Customer Service Bulletin
Commercial Business Group

Groundsmaster® 300 Series

Subject: **Seat Suspension Update.**

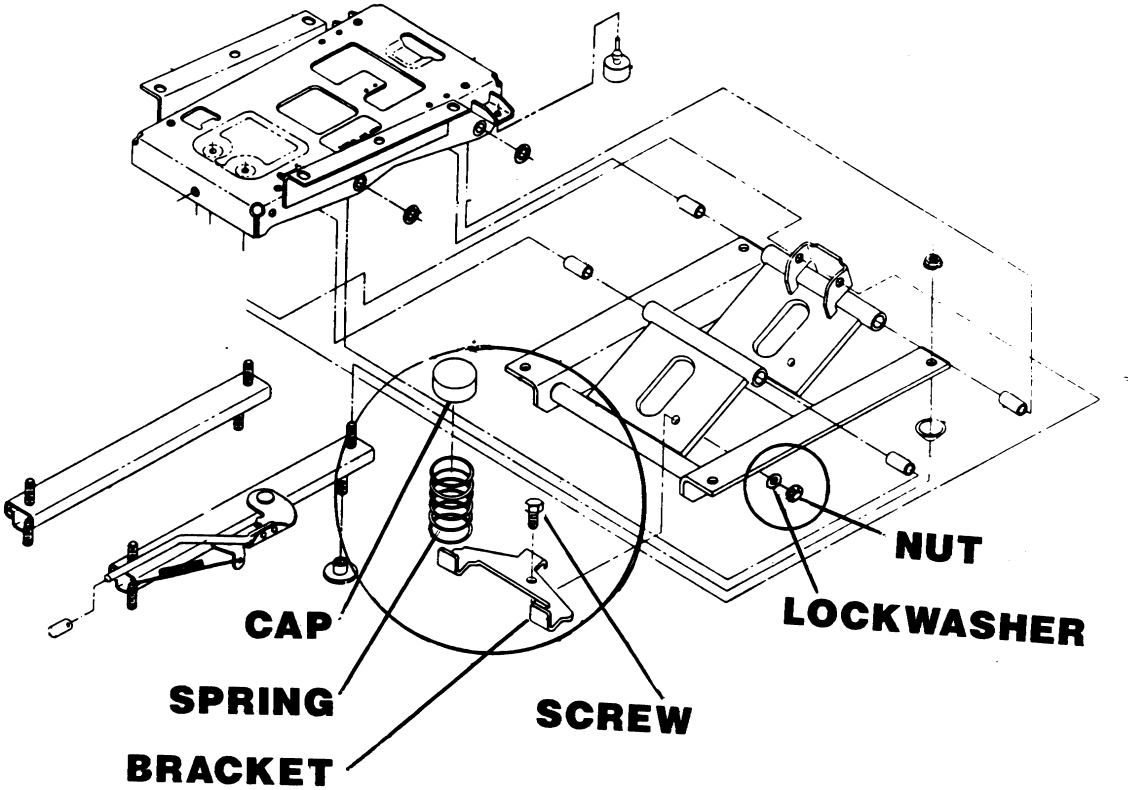
The suspension in Deluxe Suspension Seat Kit (Model #30772) now has two Secondary Springs to provide additional suspension. The Secondary Springs control the last 1-2 inches of seat suspension travel and improves the ride for heavy operators.

Secondary Springs are available and can be installed on earlier Seat Kits using the parts listed in the quantities below. The new parts are circled in the diagram below for easier identification. Parts are available through your local Toro distributor.

2)	93-3163	Spring
2)	93-3164	Cap
1)	93-3165	Bracket
1)	322-6	Screw
1)	3217-6	Nut
1)	3253-33	Lockwasher
